# LACKENBY ENVIRONMENTAL STATEMENT

VOLUME 3: TECHNICAL APPENDICES  
APPENDICES TO CHAPTER D  
(NOISE AND VIBRATION)

# **Appendix D1: Consultation correspondence**

**From:** Mick Gent <Michael.Gent@redcar-cleveland.gov.uk>  
**Sent:** 02 December 2020 14:02  
**To:** Young Youn  
**Subject:** [External] RE: Noise assessment approach - proposed developments at Dorman Point / Foundry / Lackenby / Long Acre / Steel House sites

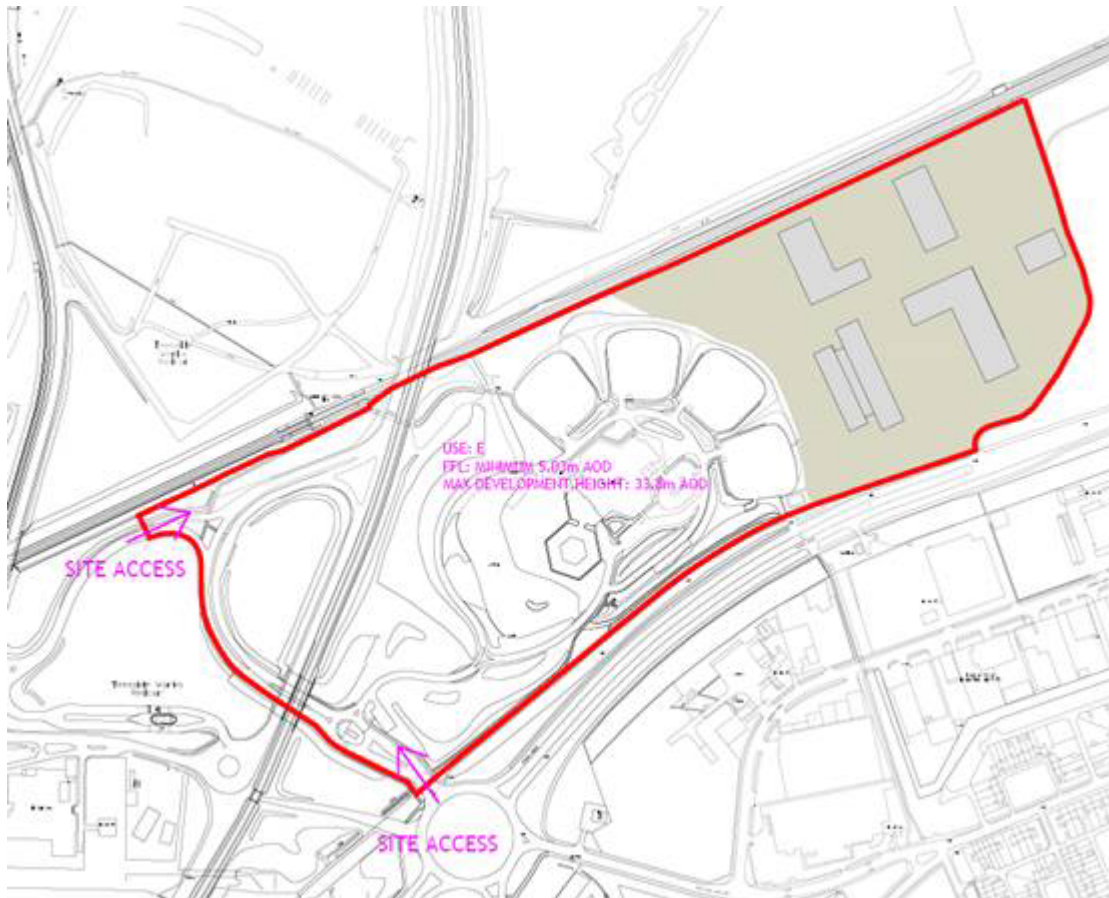
We have daily update on this proposal. Attached image below shows the existing office building and the proposed buildings on the eastern side of the site boundary.

It is our understanding that the area shown below in grey is the actual development locations, although the site boundary does include the existing office building.

This application is for new office buildings. Does this change your response? As I thought, there may have been bit of misunderstanding of the application.

Steel house has previously operated has offices - so yes ambient noise level will be fine, providing the plant room is in the same location as previous.

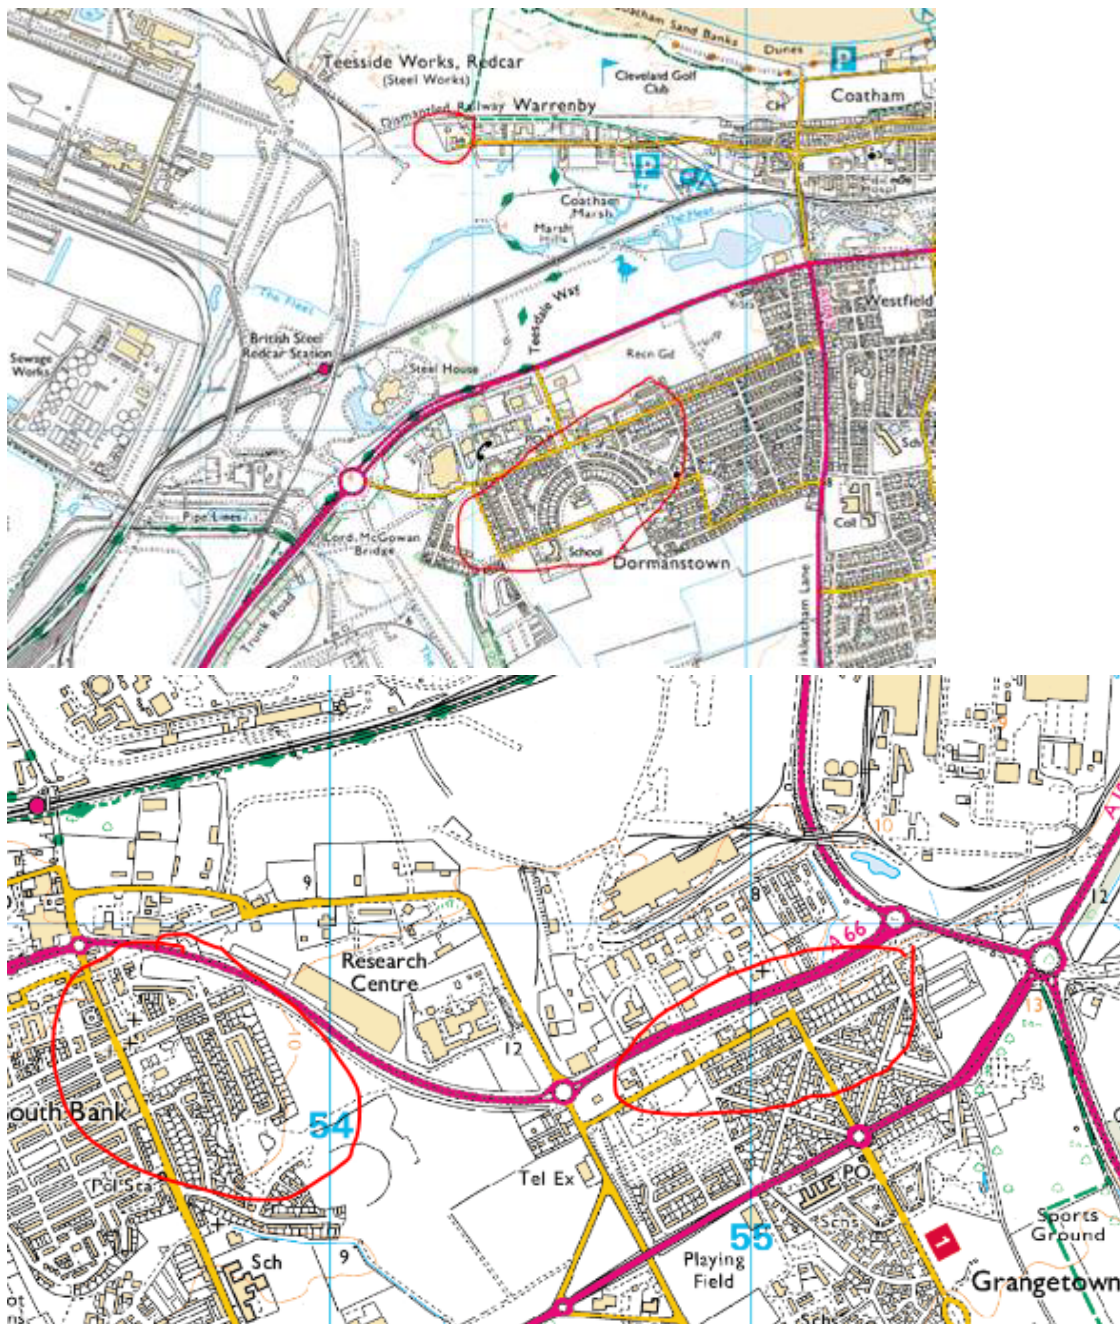
Highlighted closest residential properties circled in red below.
